Project No. 0606

Re: **Clair-Maltby 11.3 Draft Secondary Plan
 Final Draft for Community Engagement June 16, 2021**

I am the planning consultant providing these comments on behalf of South Edge Ltd., the owner of 2007 Victoria Road South, located within the Clair-Maltby Secondary Plan area located to the south of Rolling Hills.

Schedule B – Land Use Plan (DRAFT)

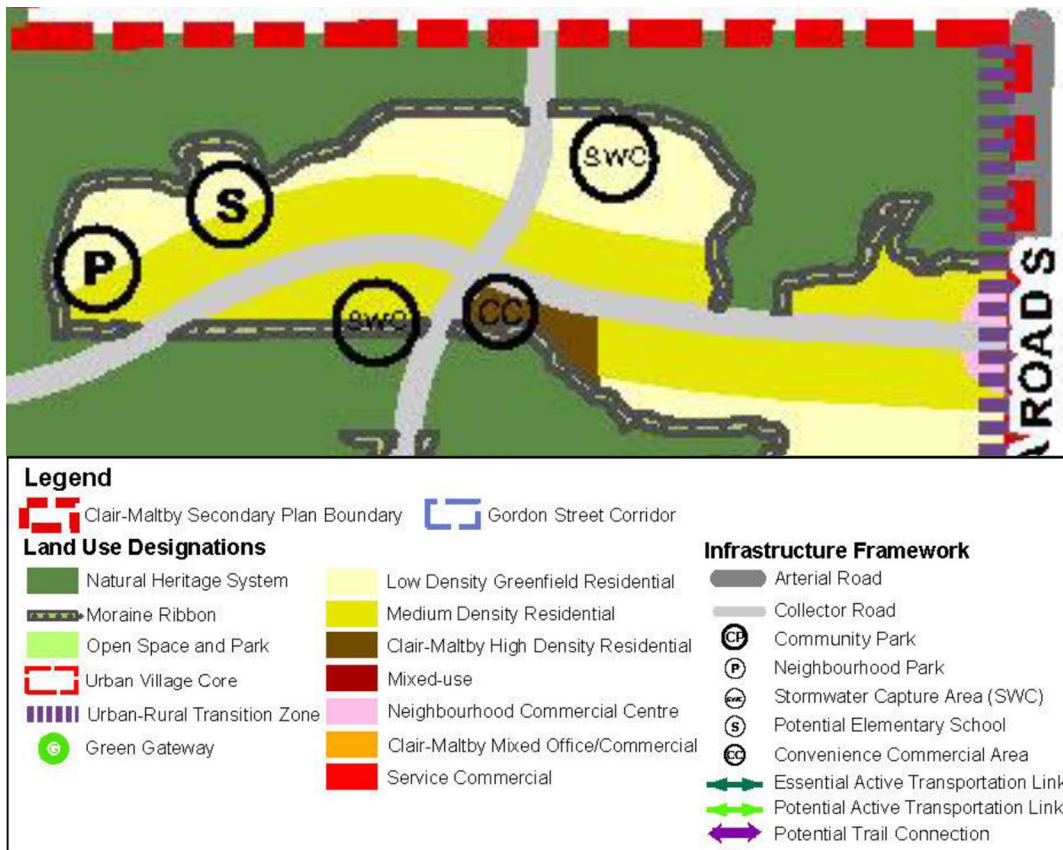
As noted in the attached letter from the owner's solicitor, the Draft Secondary Plan mapping is not consistent with the **OPA No. 42 settlement mapping**. The moraine ribbon is a land taking beyond the designations within the agreed to minutes of settlement. The owner is requesting that the Clair-Maltby mapping and policies be revised to be consistent with the minutes of settlement.

With respect to the **moraine ribbon** shown in the Draft Clair-Maltby mapping, this feature is neither a required environmental element since the Natural Heritage System features and buffers are already identified and protected within the Official Plan designation, nor is it clearly parkland dedication in the draft secondary plan policies. The moraine ribbon may be included as trails and parkland and if this is the case it should be included in the required parkland dedication requirement and be clearly articulated in the policies. Unfortunately, the moraine ribbon is not located where there are pedestrian and cycling desire lines of travel. The moraine ribbon proposal will result in land needed to provide housing and other uses within the urban area not being available. Approximately 46% of the Clair-Maltby secondary plan area is protected as part of the Natural Heritage System. In addition, there will be schools, parks, stormwater management areas and newly proposed stormwater management overflow areas, and roads which will all reduce the land available for housing and other urban land uses. The moraine ribbon should not be included within the secondary plan. Instead, there should be a policy to accept a percentage of the trail connections as part of the required parkland dedication received by the City.

There are two small Neighbourhood Commercial Centre designations along Victoria Road South and a Convenience Commercial symbol indicated on the subject property. These three small commercial designations should be removed from Clair-Maltby Secondary Plan mapping as they apply to the subject property. Rather than map these **small commercial areas** on the plan, the policies should permit convenience commercial uses within residential designations as per the current Guelph Official Plan policies. If there is market demand for these small commercial areas then they will be provided. If there is no market demand it is not reasonable for the landowner to have to amend the Official Plan to remove these designations in the future. A policy approach will allow flexibility for the market demand for commercial to be met.

There is a new **Stormwater Capture Area** symbol shown on the subject property. The draft policies refer to an overflow area for stormwater which may have the potential to sterilize large areas of land to store stormwater rather than designing stormwater management facilities to actively treat and infiltrate stormwater. This property has a large area in the north west corner (within the Natural Heritage System) that can naturally accommodate stormwater overflow. The "SWC" symbol should be relocated to this feature. The OPA No. 42 minutes of settlement for this property include provisions that address modifications to the Significant Landform policies allowing for essential storm water outlets for treated Stormwater discharge. The landowners have been requesting a technical meeting to review the engineering approach for this area and we would appreciate this technical meeting being scheduled by the city.

We question the need and the appropriateness for the **collector road** to connect to the north through the Rolling Hills community. The north portion of the collector road should be deleted from the Secondary Plan.
